TOWN OF COLCHESTER
APPLICATION FOR
FINAL PLAT REVIEW

- 5) PROJECT STREET ADDRESS: 242 Severance Road
- 6) TAX MAP & PARCEL #(can be obtained at Assessor's Office) Tax Map 4, Parcels 30-1, 30-2, 30-3, 30-5, 30-6, 30-7, 30-8, 30-9, 30-10, 30-11, 30-12, 30-13

- 7) PROJECT DESCRIPTION
 - a) Please note if new lots are being created and whether or not the request is for a regular subdivision, planned residential development, or planned unit development: _____
This application is for a planned unit Development that will create new lots.

IRELAND INDUSTRIES SUNDERLAND FARMS COMMUNITY

SOUTHEAST UTILITY PLAN

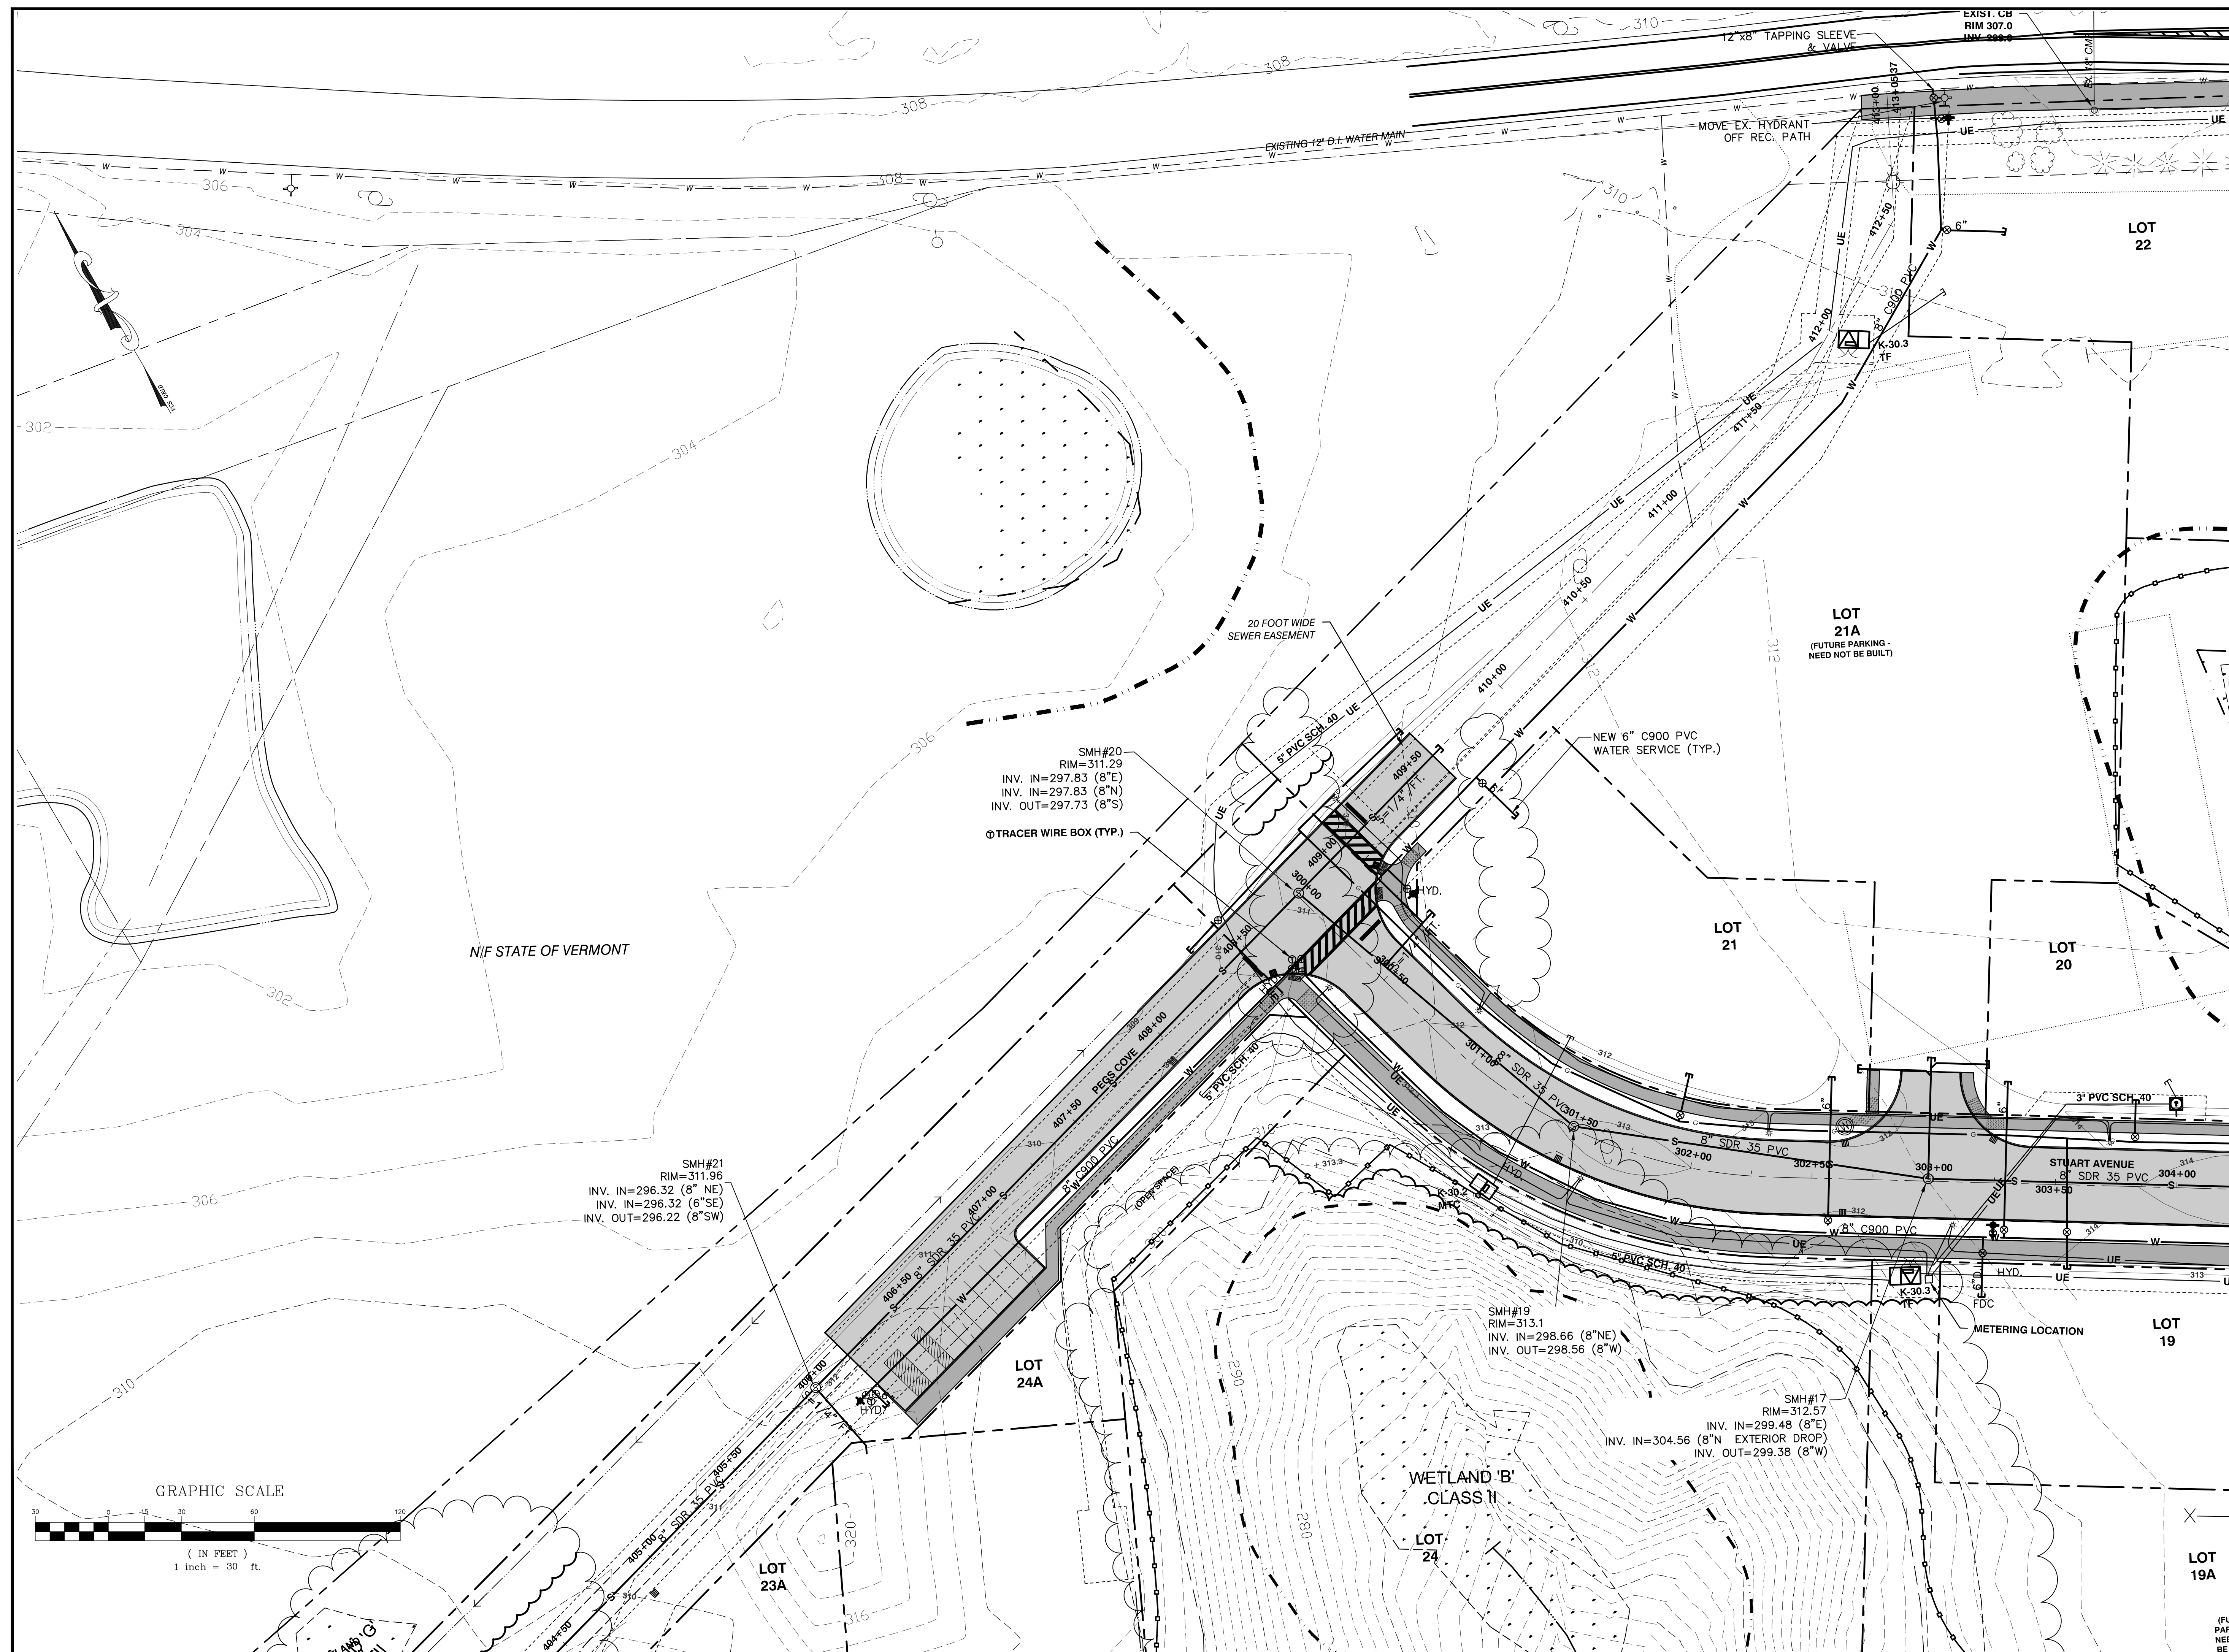
4. Per item #4, two (2) 90 degree bends are represented on Dylan Avenue (Sheet C3.2) near Sta 107+00. Replace each bend with 45 degree elbows. **This has been revised on Sheet C3.2.**

4. Per item #4, two (2) 90 degree bends are represented on Dylan Avenue (Sheet C3.2) near Sta 107+00. Replace each bend with 45 degree elbows.
 5. Sheet C7.4 Section 2.14. Please eliminate Waterous Pacer fire hydrants. CFD#3 recommends the Kennedy K81 over the Mueller hydrant.

SHEA DRIVE
ROAD PROFILE
STA. 200+00 -
209+73

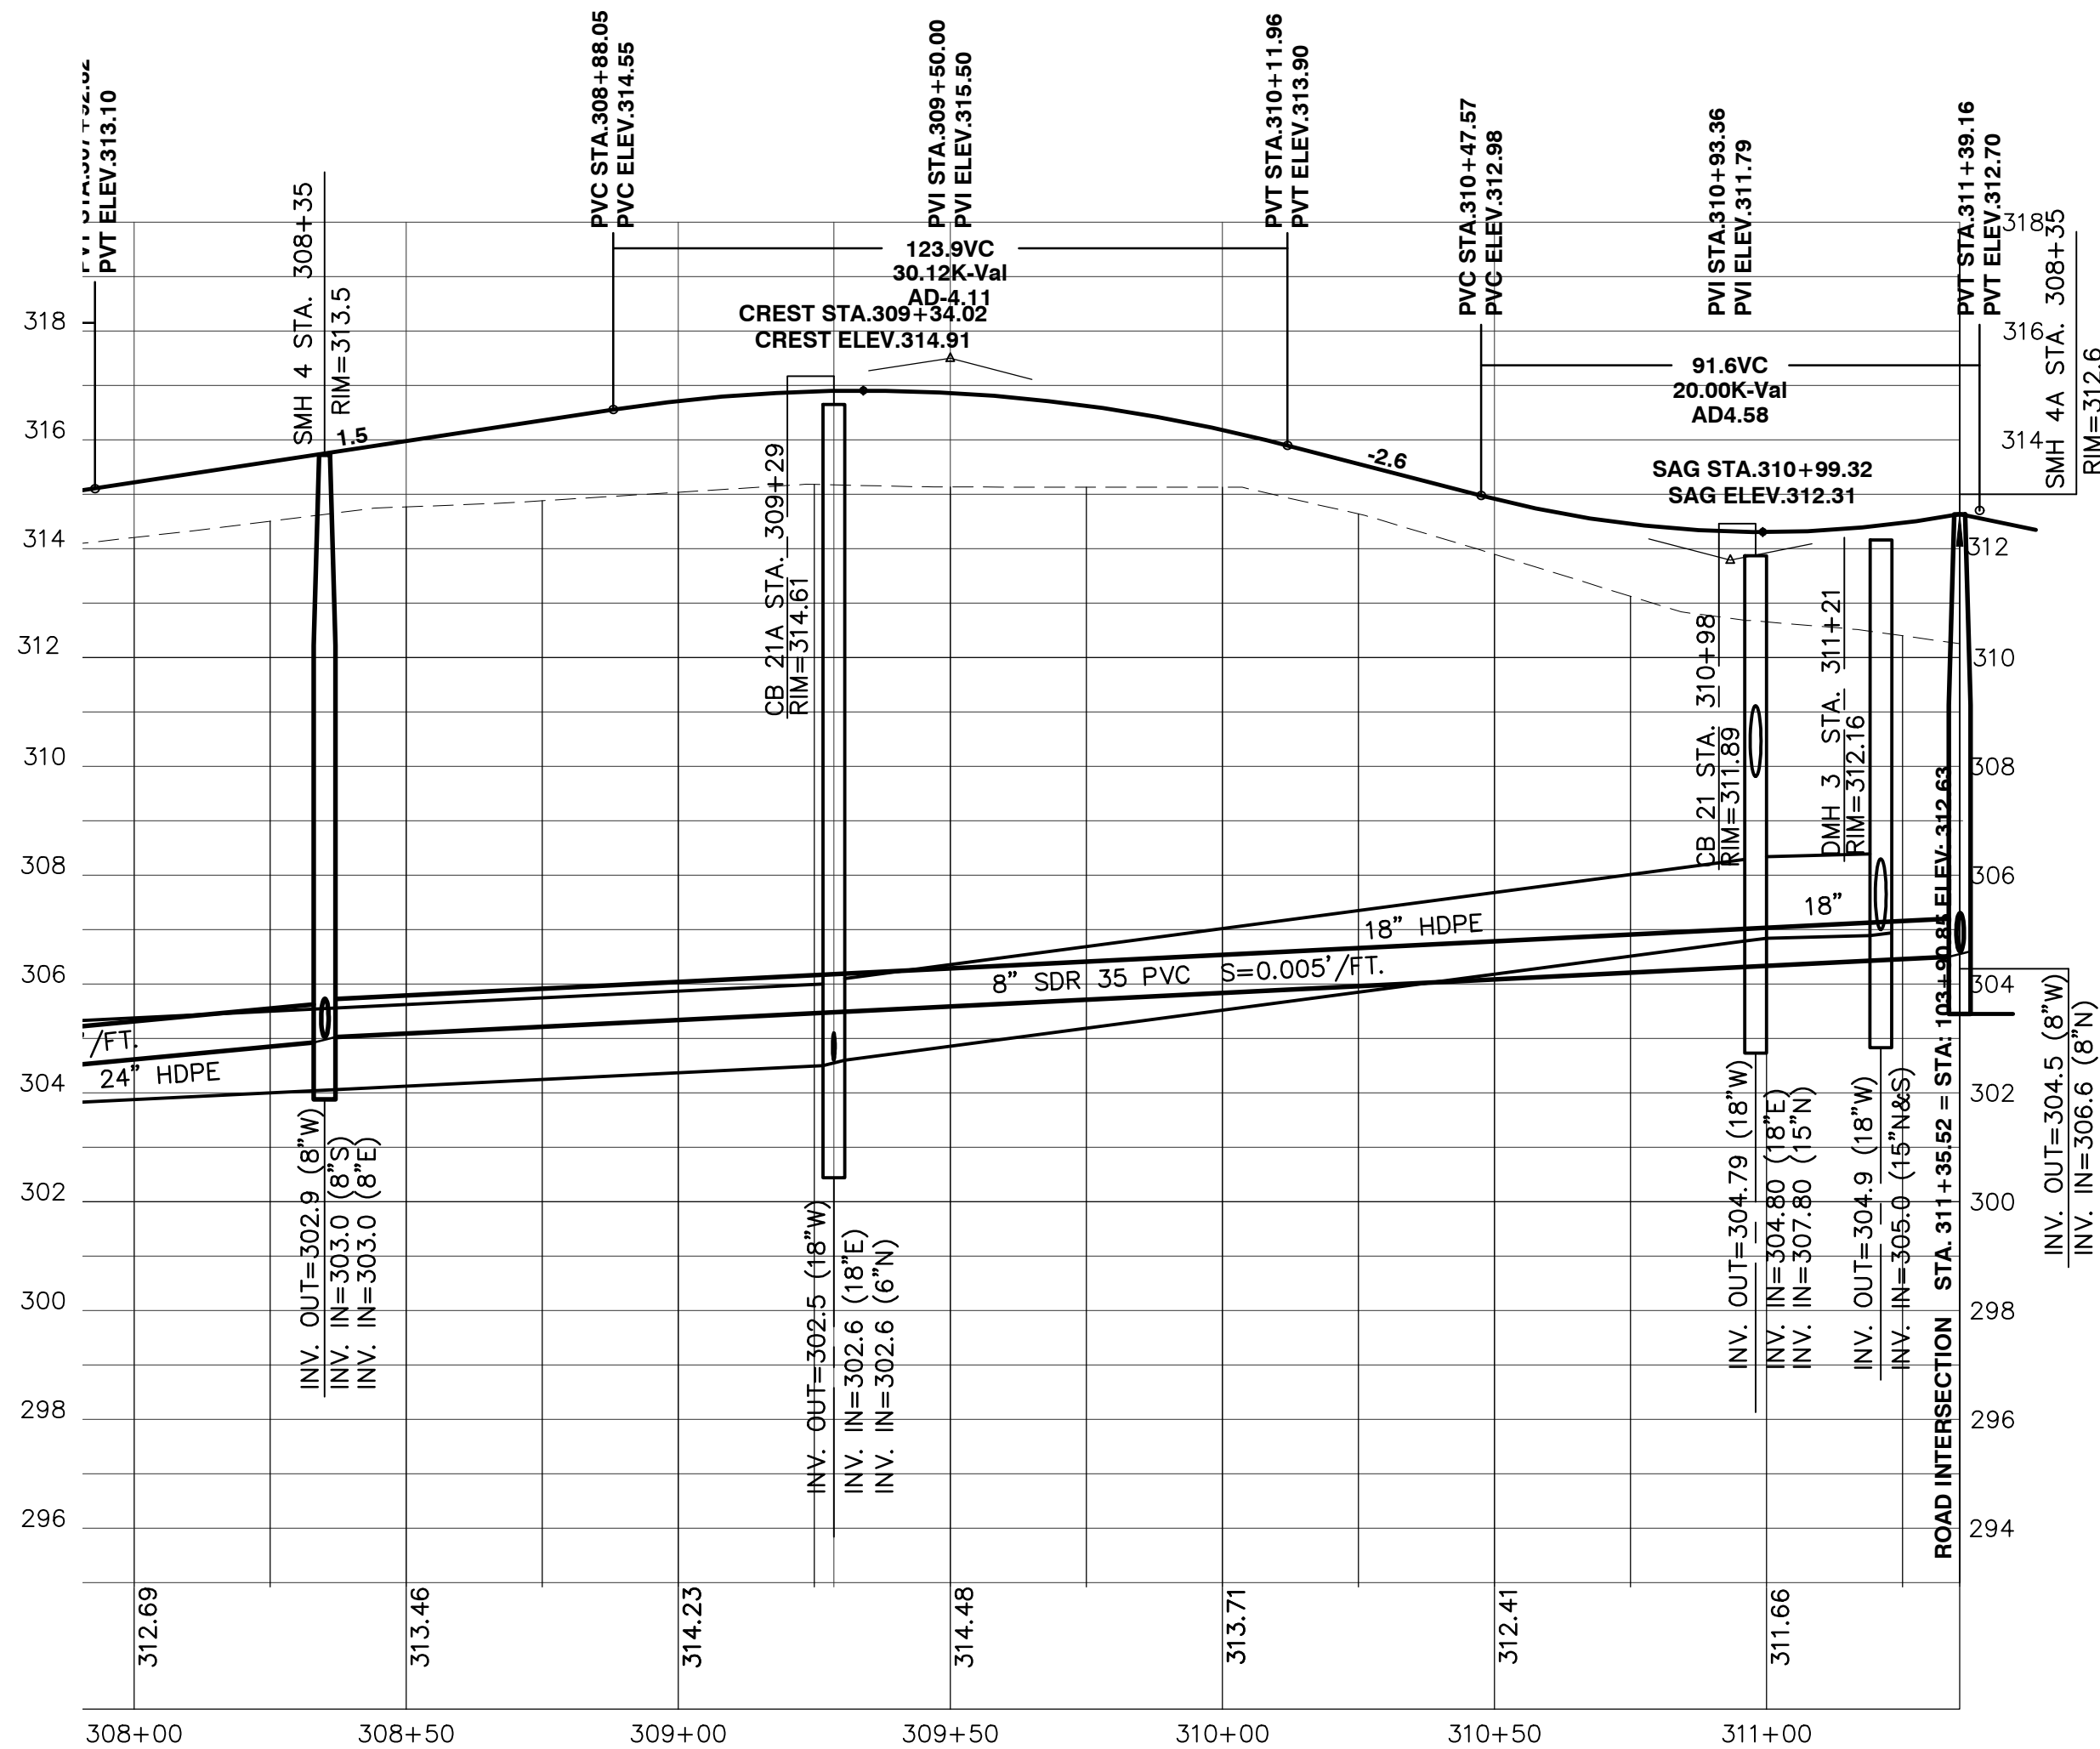
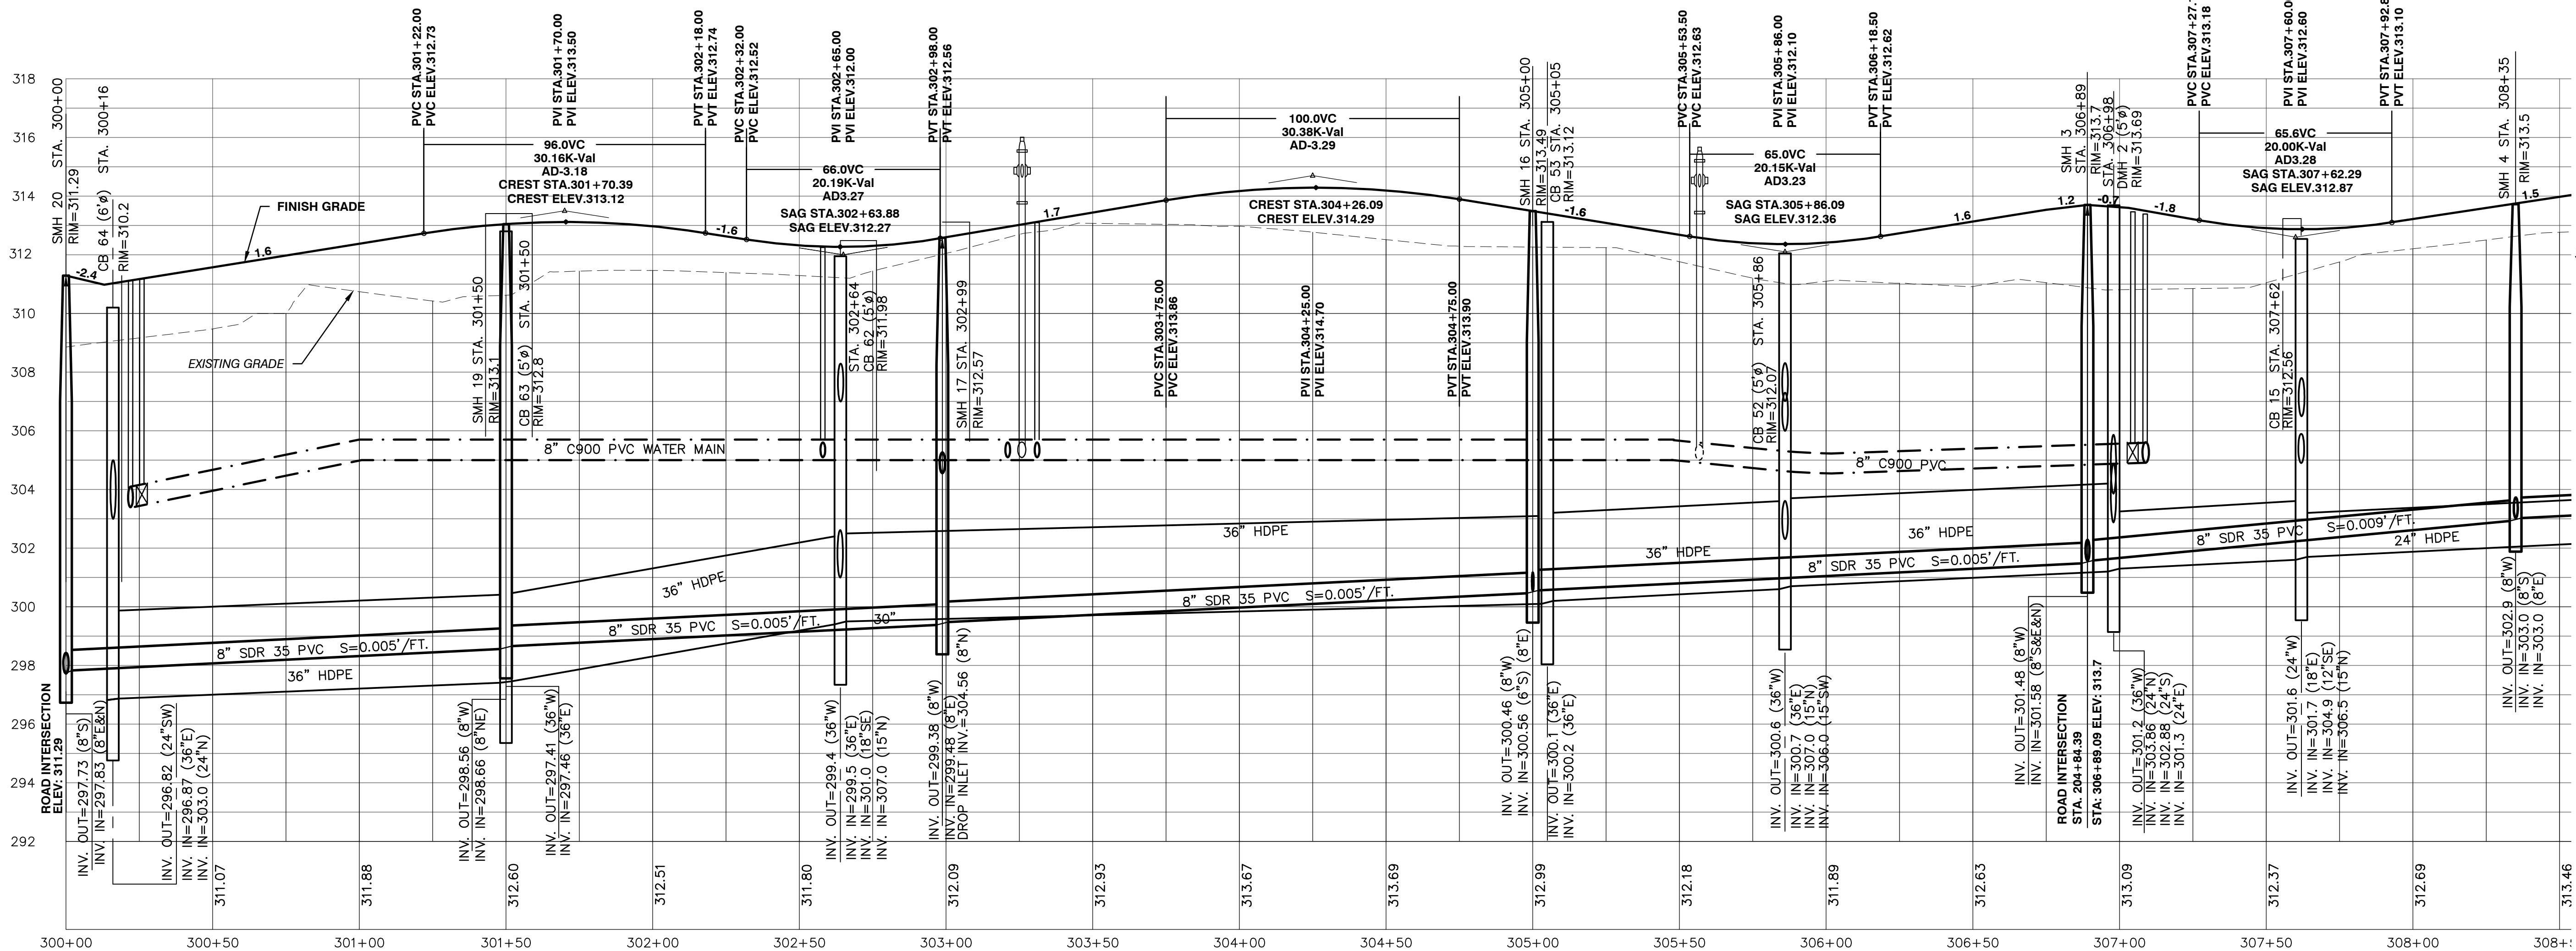
3. Per item #3 of this checklist, water main depths exceed 9 feet on Shea Drive (Sheet C4.1) in at least two locations (Sta 202+45 and Sta 208+72). This should be avoided. **On Shea Drive (Sheet C4.1) in at two locations (Sta 202+45 and Sta 208+72) the depth exceeds the 9 feet due to gravity storm line vertical alignment constraints and the minimum 18" vertical separation. At Sta 202+45 the water line has been adjusted to be 9.5 foot maximum below finish grade. At Sta 208+72 no adjustment was made due to the gravity sewer and storm constraints and vertical separation requirements.**

3. Per item #3 of this checklist, water main depths exceed 9 feet on Shea Drive (Sheet C4.1) in at least two locations (Sta 202+45 and Sta 208+72). This should be avoided.
